Consideration of a request for a Conditional Use Permit and Site Plan Approval for "Stoneworld", a proposed storage yard on 8.421 acres, located at 2900 South Highway 89 in the Industrial and Manufacturing (I&M-1) Zone. The subject property was rezoned to I&M-1 in November of 2019.

MAPLETON CITY SITE PLAN REVIEW

On or about August 20, 2020 Brett Robison re-submitted a site plan for the Stoneworld storage yard proposed at approximately 2900 South Hwy 89 in the I&M-1 zone. The items below include 1) requested changes to the submitted plans, 2) other items required as part of the application and/or 3) informational items regarding city standards. **All items that include an * and are bolded are required prior to any public hearings.**

STONEWORLD
SITE PLAN

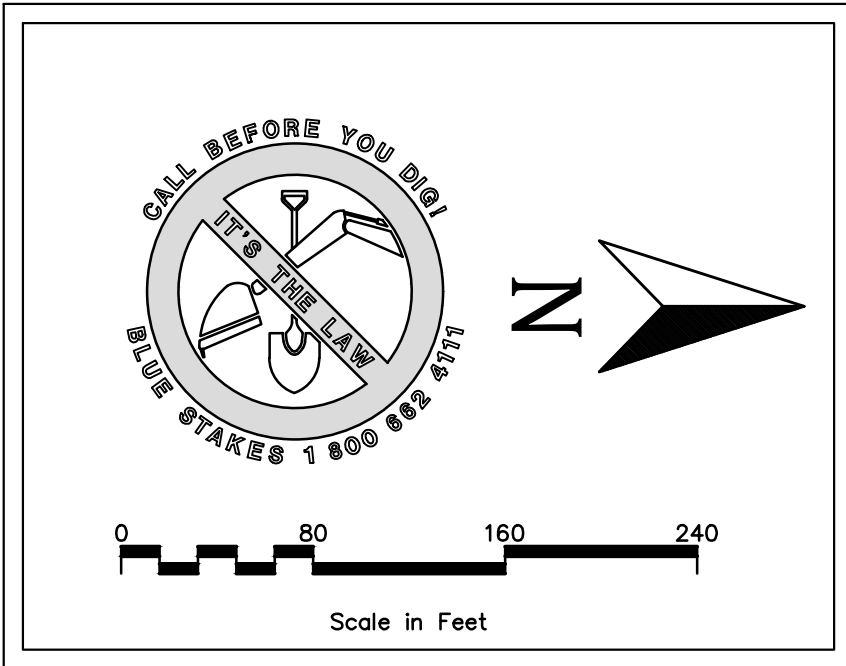
1. Screening and Landscaping Requirements:
 - a. A sight obscuring fence of six feet (6') in height shall be required along all side and rear property lines behind the front edge of the primary building or at the setback line. **As the frontage along HWY 89 presents a "public view" of the site, it must be made of masonry (See definition of "Storage Yard" MCC 18.08.010). This masonry wall will be located adjacent to the storage yard so that the required front landscaping is visible to the public. The rolling gates must be located between the segments of wall and not along the property line.** Other required fences can be masonry, vinyl, chainlink with closely prewoven vinyl privacy slats, or other closely equivalent materials approved by the Planning Commission. The fence may be topped by a set of 3-strand barbed wire up to twelve inches (12") in height. **Because there is no parking in front of the existing buildings, a berm is not necessary. If included, the berm does not change the requirement for the masonry wall along Hwy 89.**

- c. Detention/retention basins and ponds shall be landscaped where possible. Such landscaping may include shade and ornamental trees, evergreens, shrubbery, hedges, turf and ground cover. **How can landscaped drainage swales function simultaneously as product storage areas?**

- iii. All shrubs shall have a minimum height or spread of eighteen inches (18") depending on the plant's natural growth habit.
3. Landscape Buffers:
- a. Landscape buffers are required for transitions between dissimilar uses. **A landscaped buffer must be created between the storage yard and the existing home. The home is zoned industrially but it appears it is intended to be used residentially.**

5. Drainage: All lot drainage shall be retained on site. **The grading plan indicates proposed drainage swales along the train tracks but the site plan indicates that these areas are part of the storage. Please explain how drainage areas function while also being used as product storage areas.**

STONEWORLD
LANDSCAPE PLAN
2800 SOUTH & U.S. HWY. 89 MAPLETON, UT.

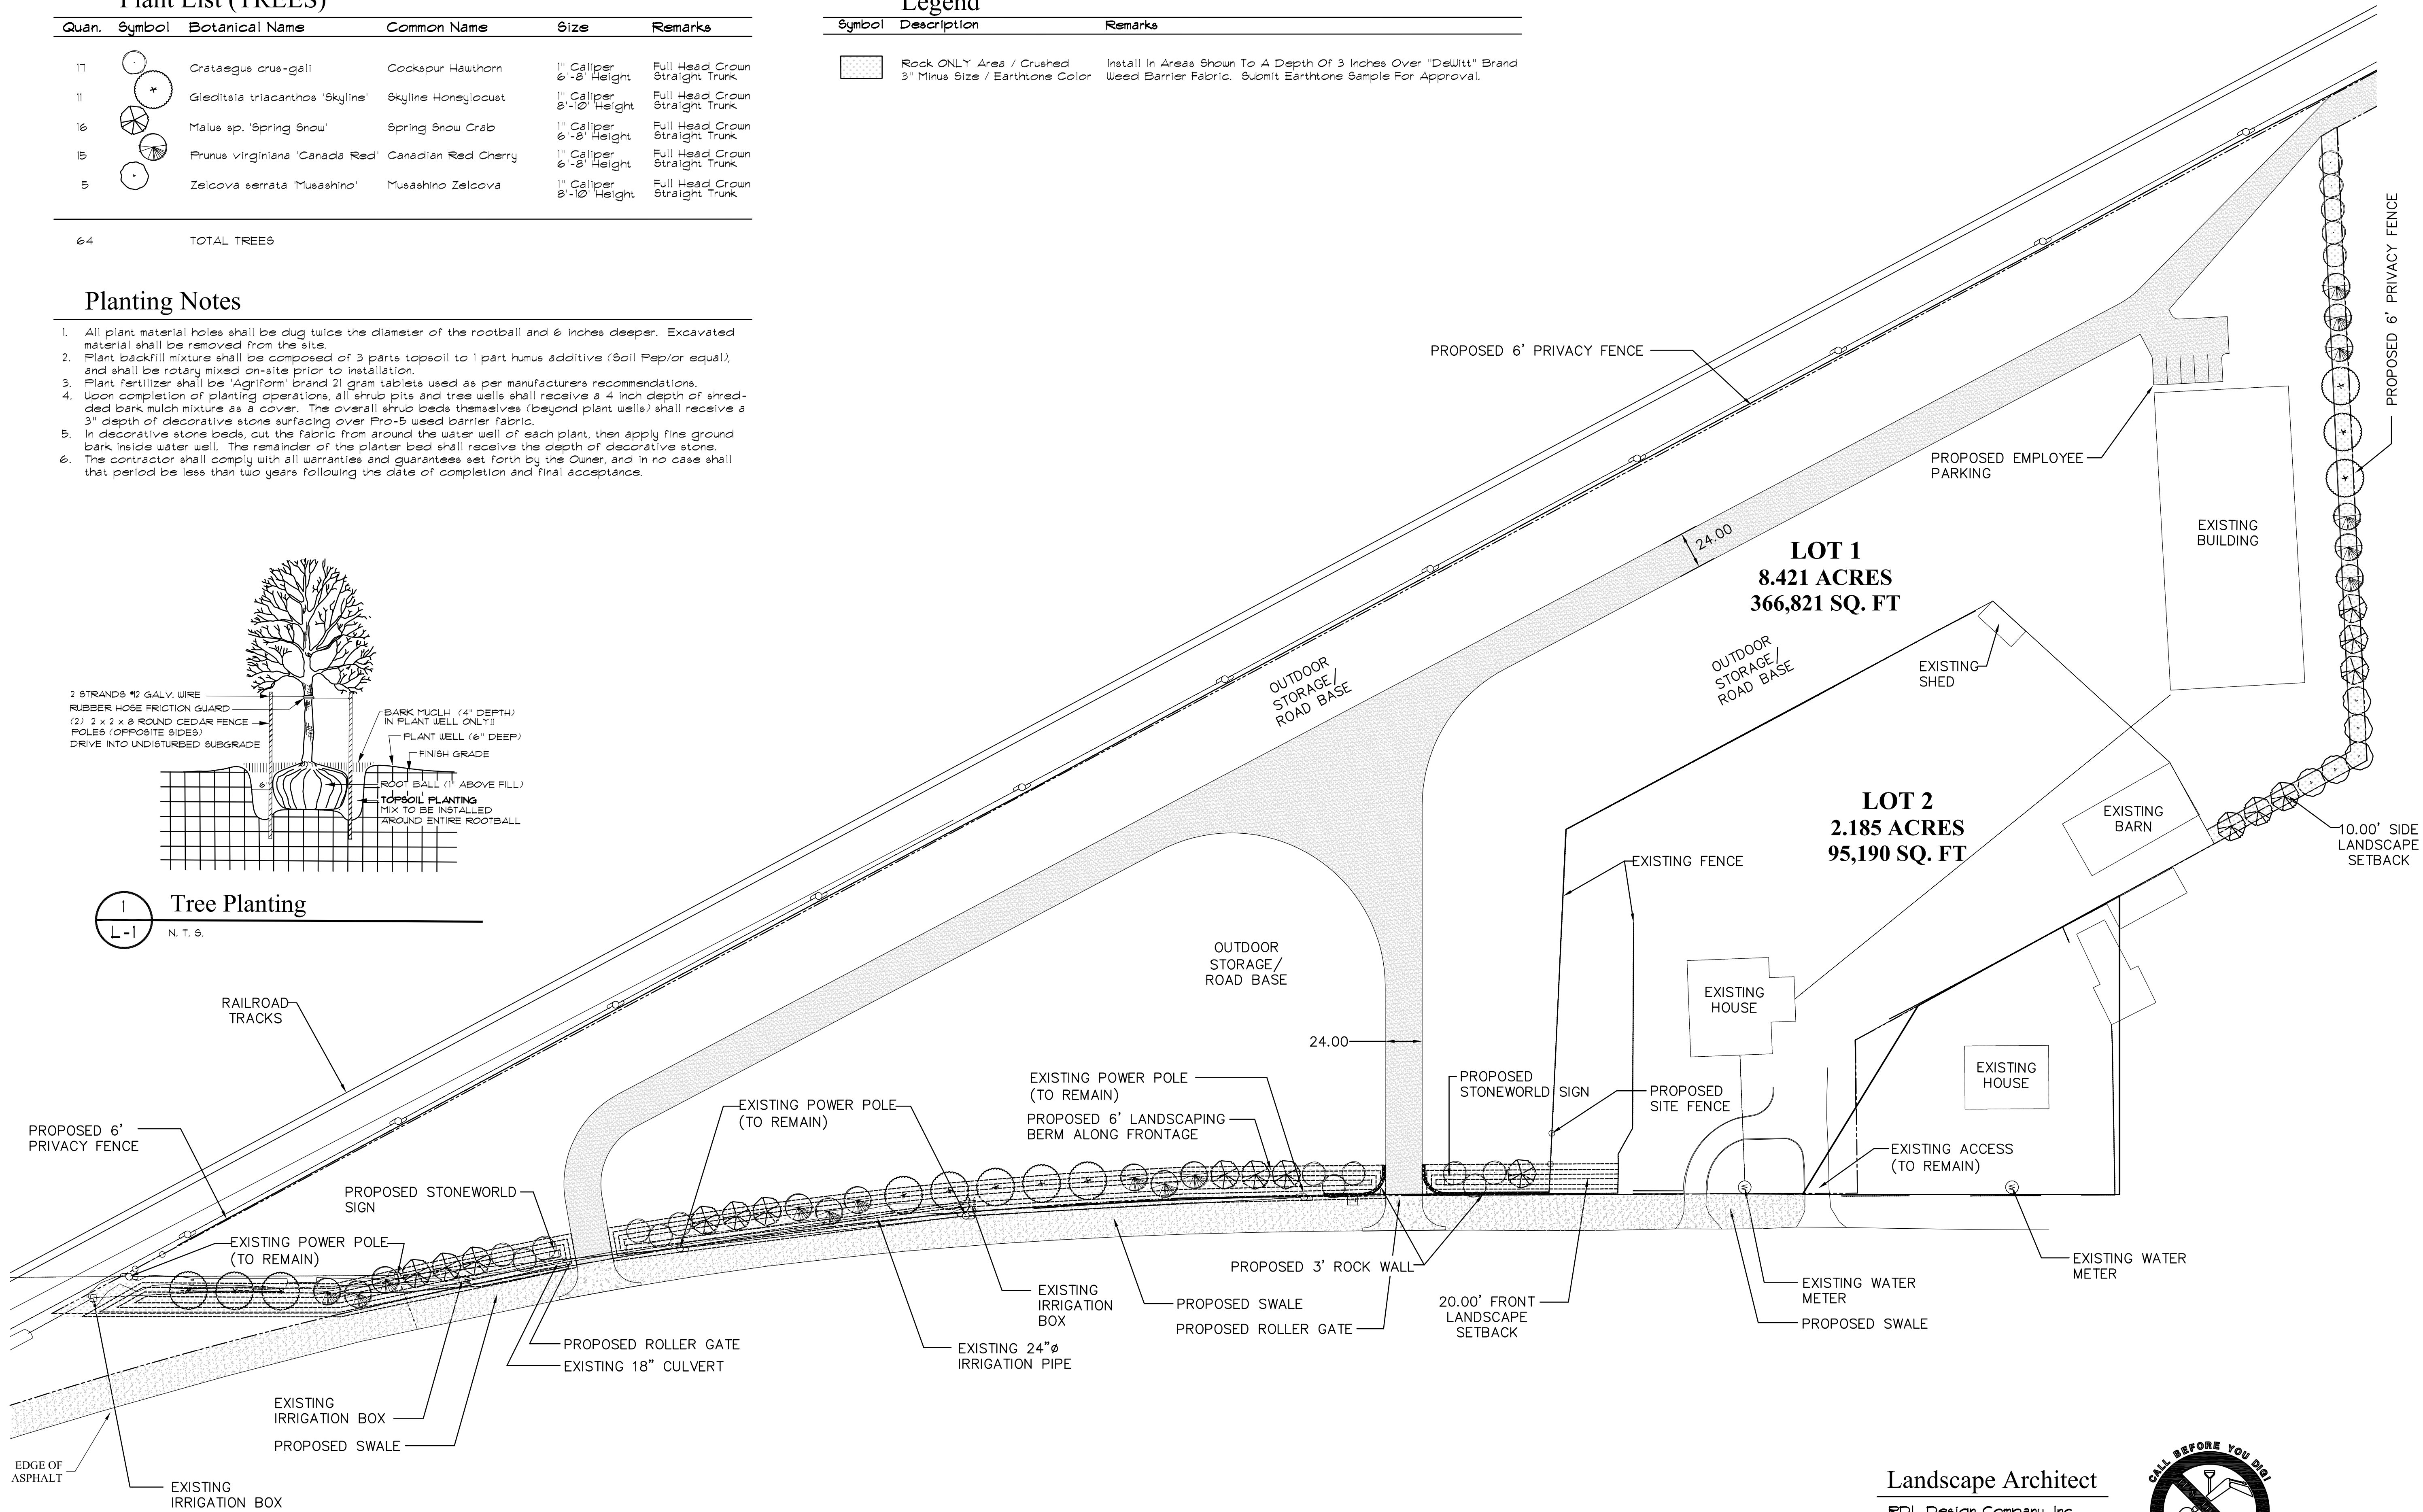
- b. All landscaped areas shall conform to chapter 18.90 of this title. Furthermore, the landscaping will contain ten (10) trees per acre, or a fraction thereof, and be at least one inch (1") caliper, measured three feet (3') from the ground. **Please include calculations that indicate compliance.**

- a. **Evergreens shall be incorporated into the landscape treatment of a site, particularly in those areas that require screening and buffering.**
 - b. **In addition to trees, foundation landscaping plants shall be placed intermittently against long expanses of building walls, fences, and other barriers to create a softening effect.**

- h. **Mulch shall not be used as a substitute for plants. Live plant material, sod, ground cover vegetation and/or the canopies of trees must cover no less than 50% of the landscaped area at full growth. Please include calculations that indicate compliance.**

- c. The width of landscape buffers shall be a minimum of ten feet (10'), subject to the following requirements:
 - i. Shade trees shall be planted at the rate of one tree for every thirty (30) linear feet of landscape buffer. **Please include calculations that indicate compliance.**

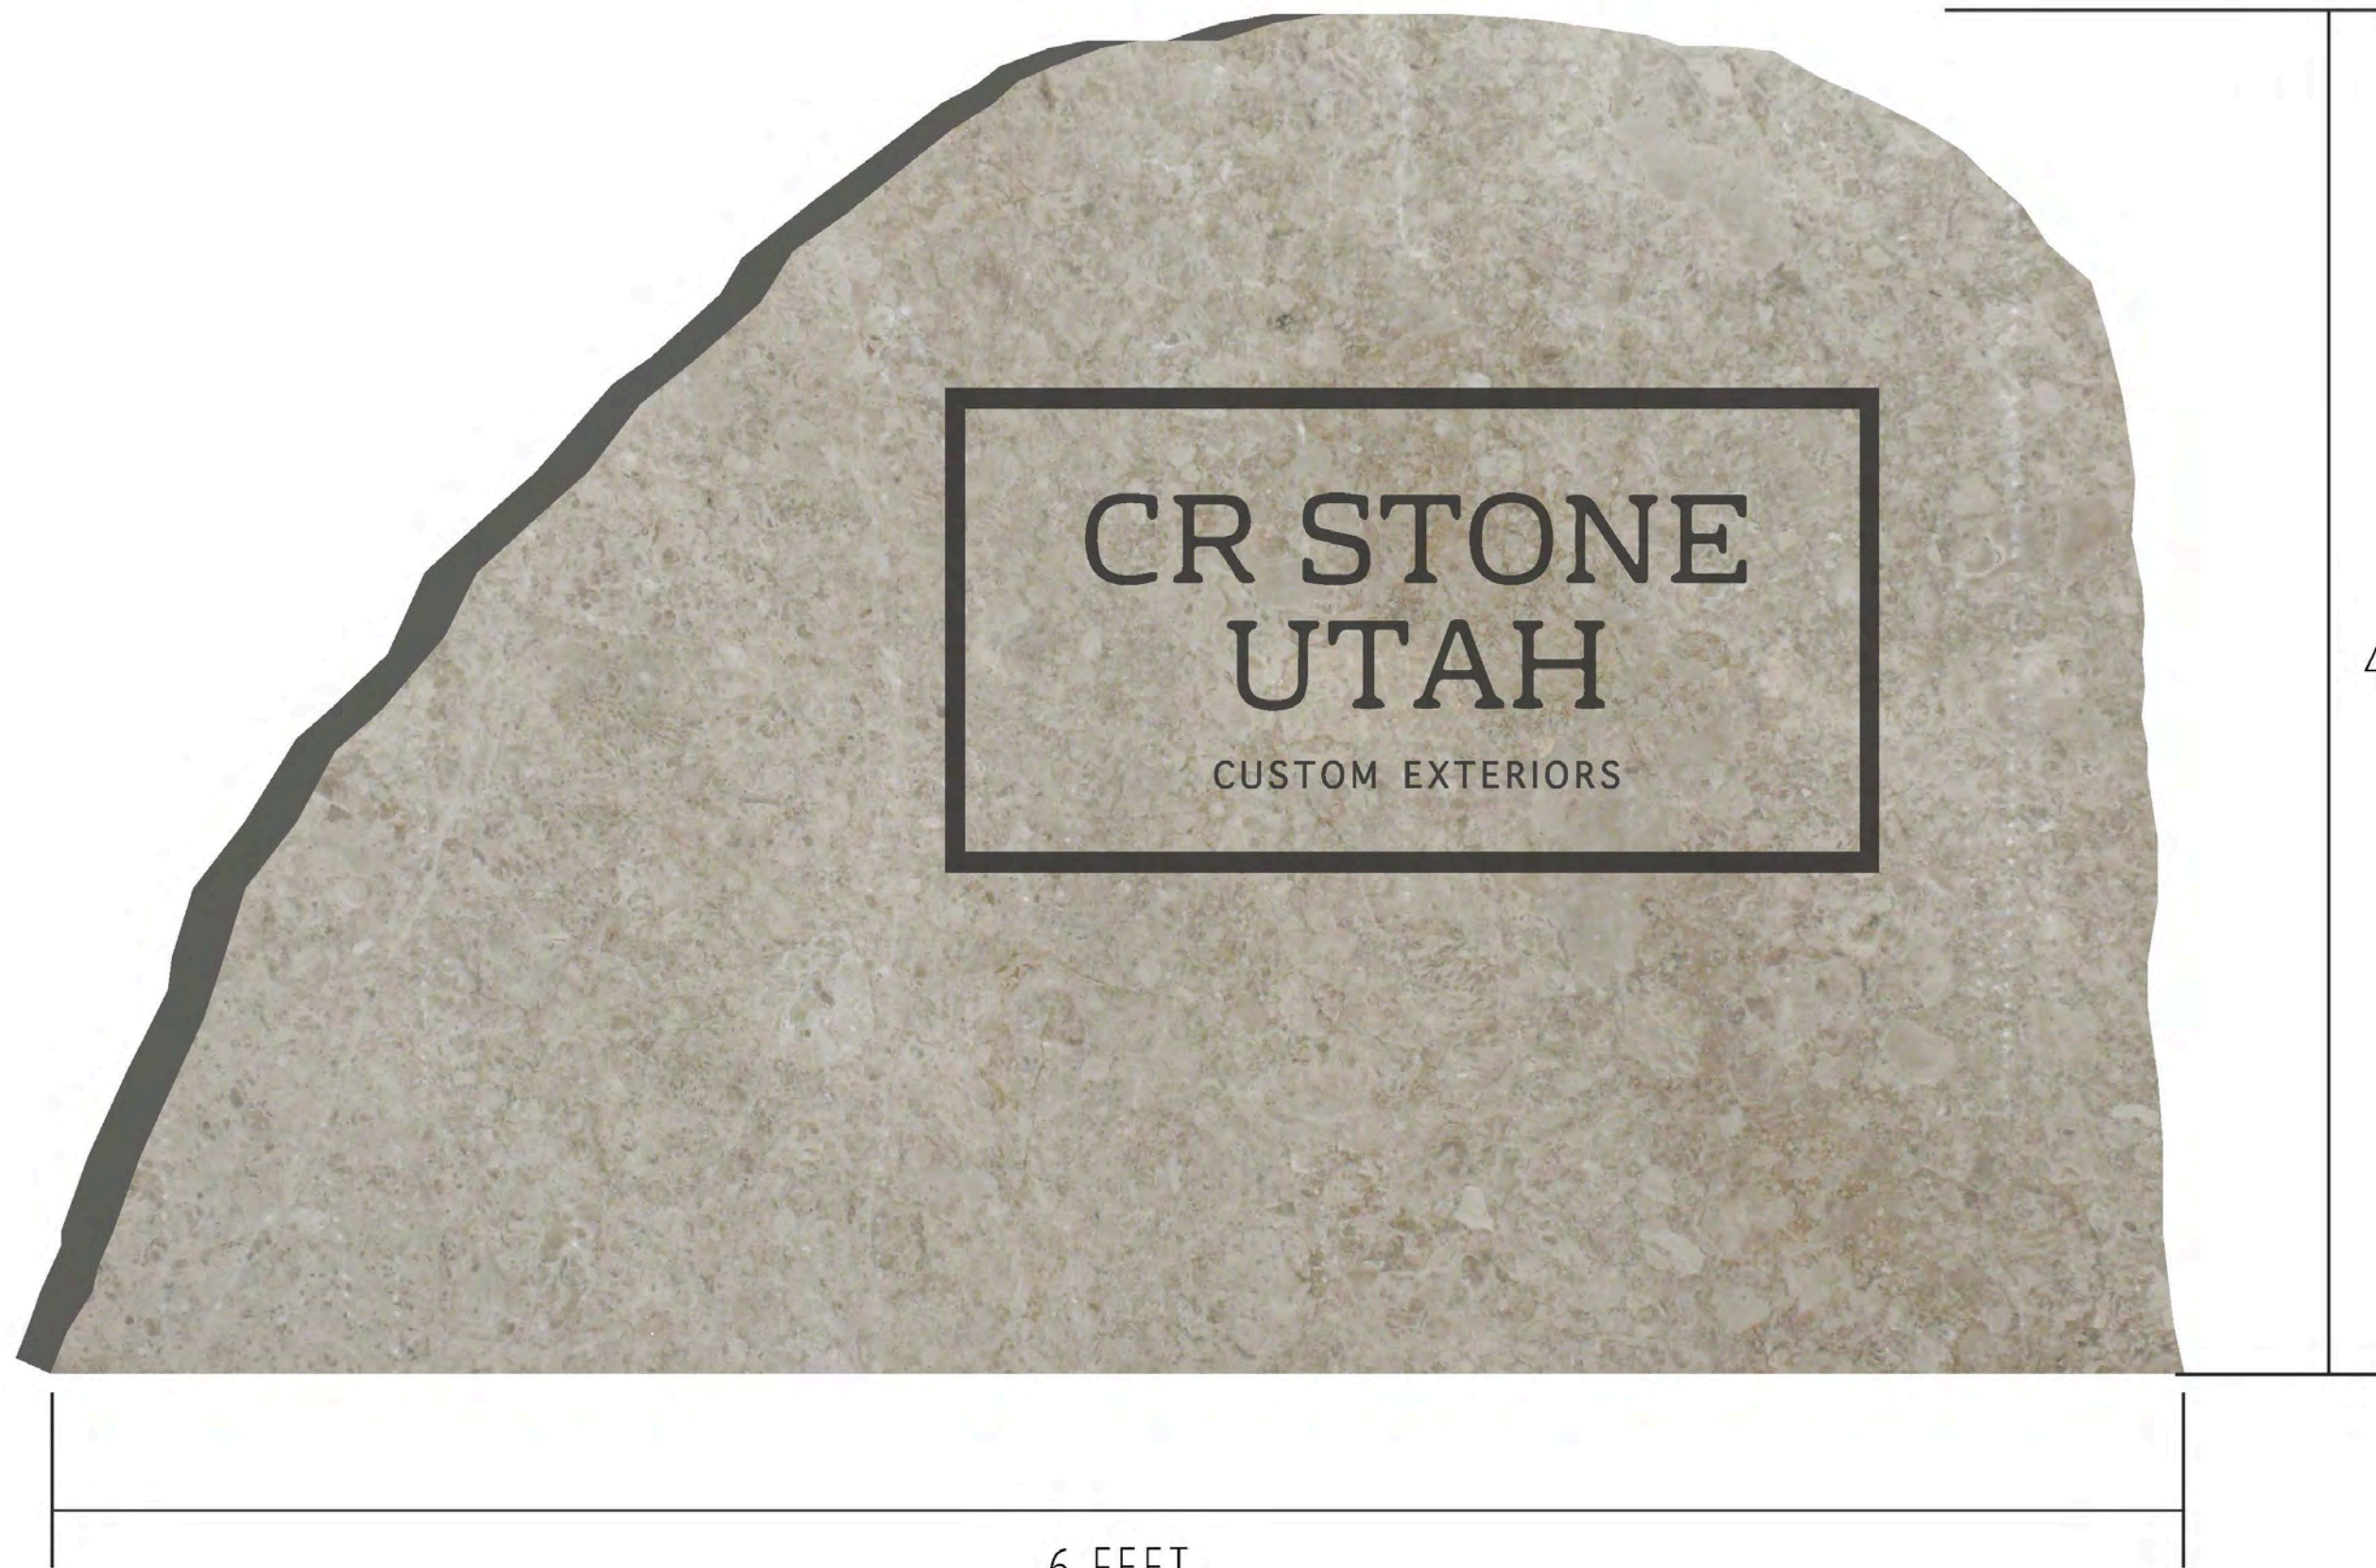
Signs – The applicant has proposed a monument sign adjacent to each of the two entrances on Highway 89. One sign per frontage is permitted as long as it is no more than 5' tall and 40 square feet. The proposed sign meets the standard but only one sign is permitted along Hwy 89.
